Tres Suenos Unit 14

City of El Paso — City Plan Commission — 11/16/2017

SUSU17-00083 — Major Preliminary

ATTACHMENT 1

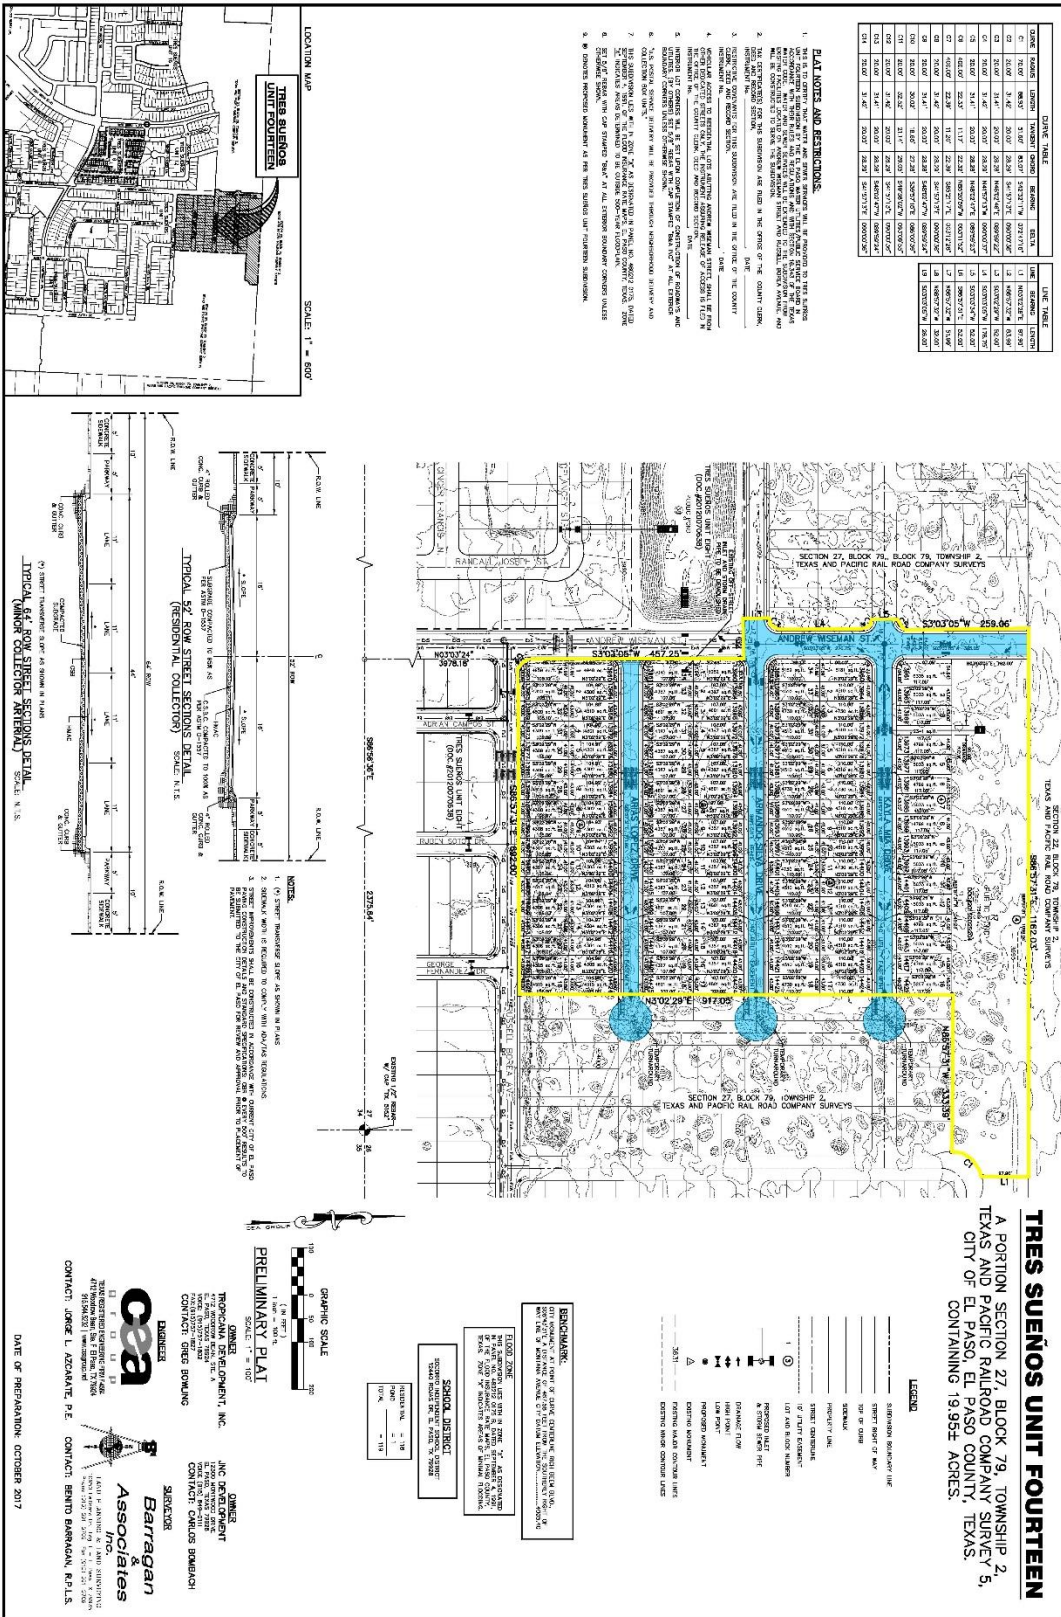
No objections. Change the following Block numbers: Change Block 1 to Block 53. Change Block 2 to Block 54. Change Block 3 to Block 55. Change Block 4 to Block 56.

ATTACHMENT 3

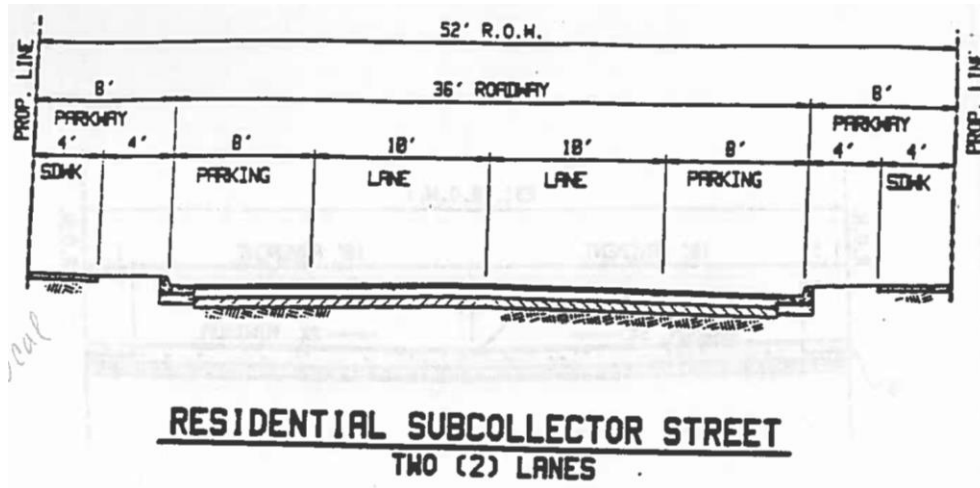
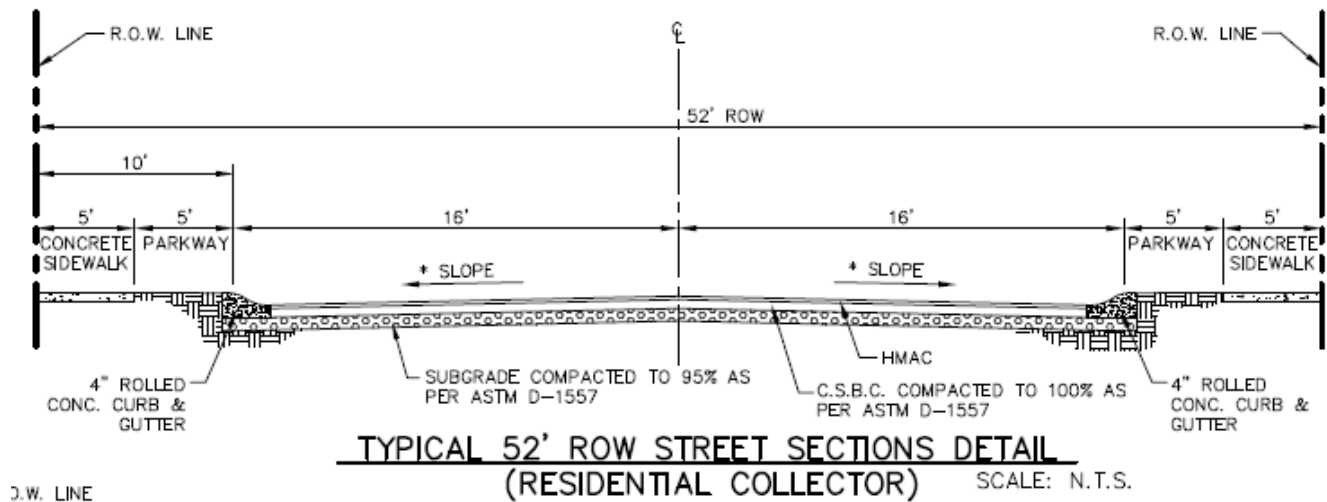
Modification No. 1: 52 foot Roadway

A modification request for Chapter 19.16.020.B.1a.(4) shall consist of a 52 foot roadway cross-sections with (2) 16-foot paved driving lanes with 4-inch rolled curb and gutter on both sides of the roadway, (2) 5-foot parkways abutting the curb and (2) 5-foot concrete sidewalks. Our request is based on maintaining continuity from the already constructed and city accepted subdivisions in the area.
